Portal Associations in P802.1CS D2.1

Norman Finn
Huawei Technologies Co. Ltd
cs-finn-portal-associations-0319-v1

P802.1CS D2.0

Figure 6-8—State machine creation

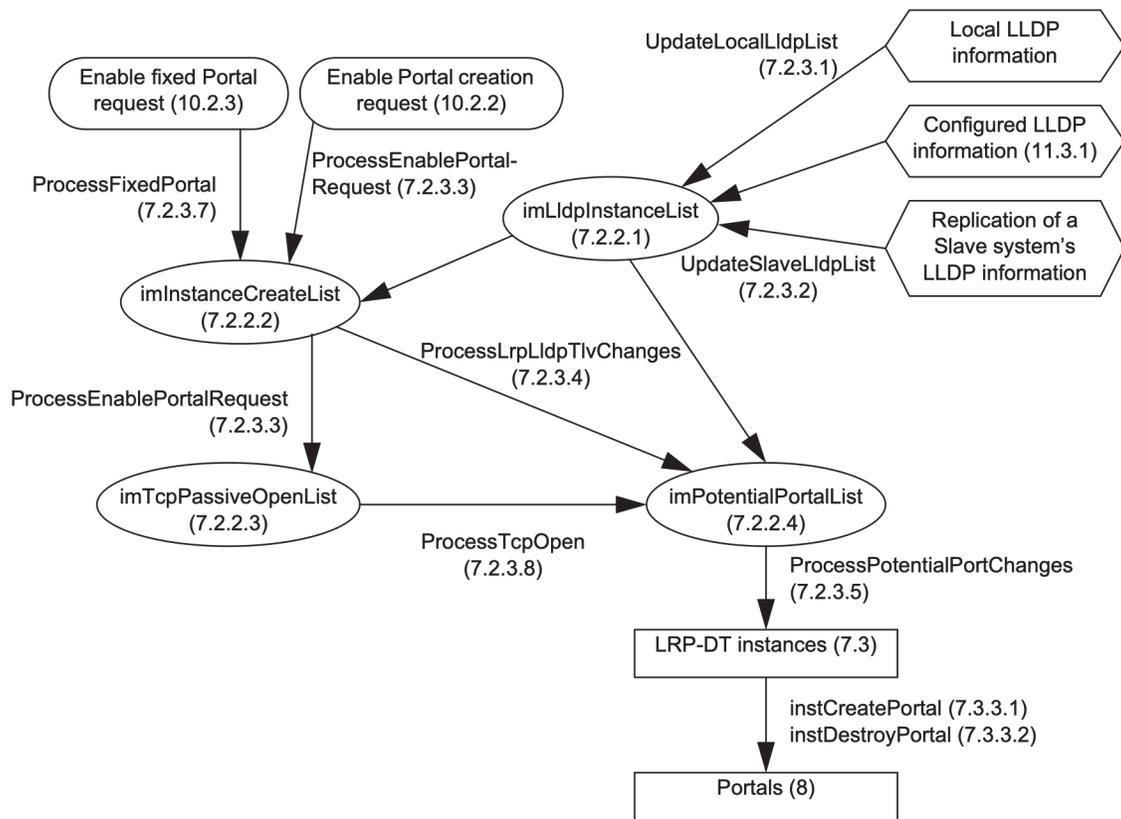
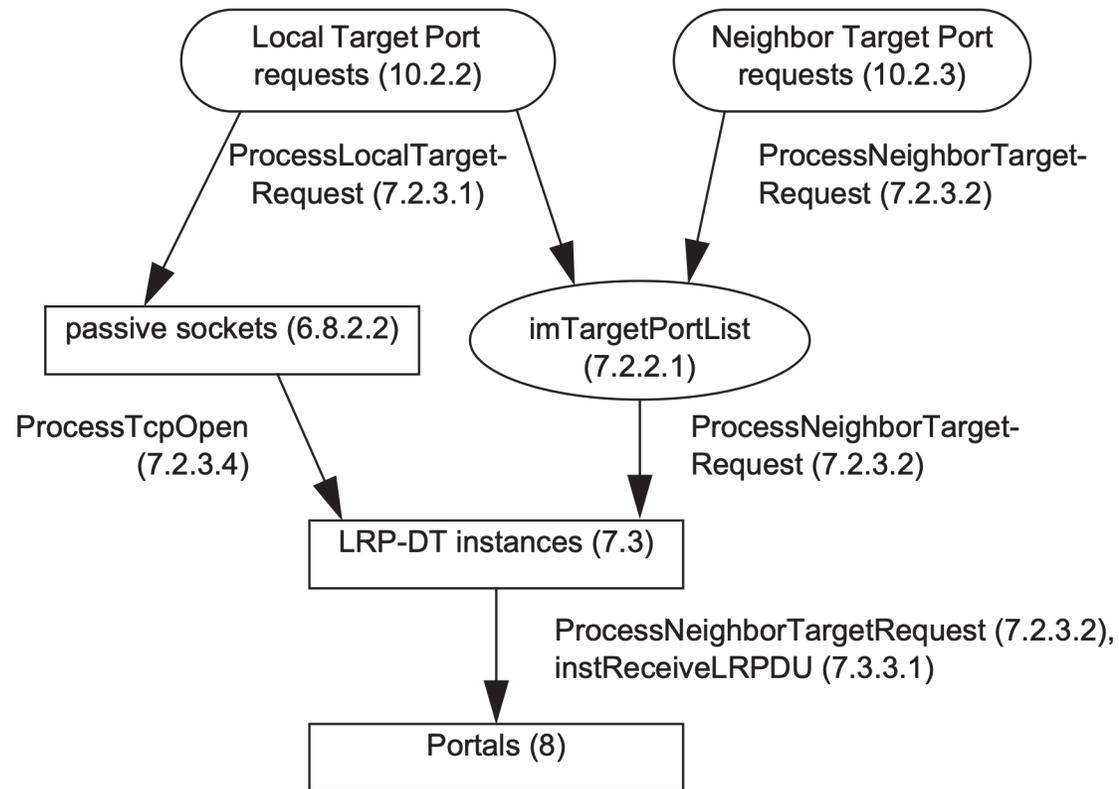
1. Clause 7.2 of IEEE P802.1CS D2.0 (the January 2019 draft), state machine creation, was very complex, and tied tightly to LLDP, even where LLDP was not required.
2. The text in D2.0 was somewhat confused, especially in the names of the primitives in Clause 10, between the creation and the operation of the LRP-DT and LRP-DS state machines.
3. The descriptions of TCP operations were vague.
4. Bottorff and Congdon suggest simplifying the state machine creation mechanism and decoupling LLDP from control of LRP by the application.

1. The application creates (via primitives) local target ports and attaches remote target ports to them. (This database can be the same information that is supplied by LLDP, if used.)
2. This database creates LRP-DT instances and, if the remote target information is complete, Portals, and the Portals start Hello transmission.
3. Passive TCP LRP-DT instances are always created. Receipt of an incoming connection creates a Portal that does **not** yet send Hellos.
4. When a Hello is received, local target port must exist. Whether remote target port is in table or not, Hello is offered to application, and if approved, Portal is created and remote port is added (if necessary) to table.
5. **Application controls the table** – not LLDP directly – so Portals and LRP-DT instances are deleted by manipulating the table.
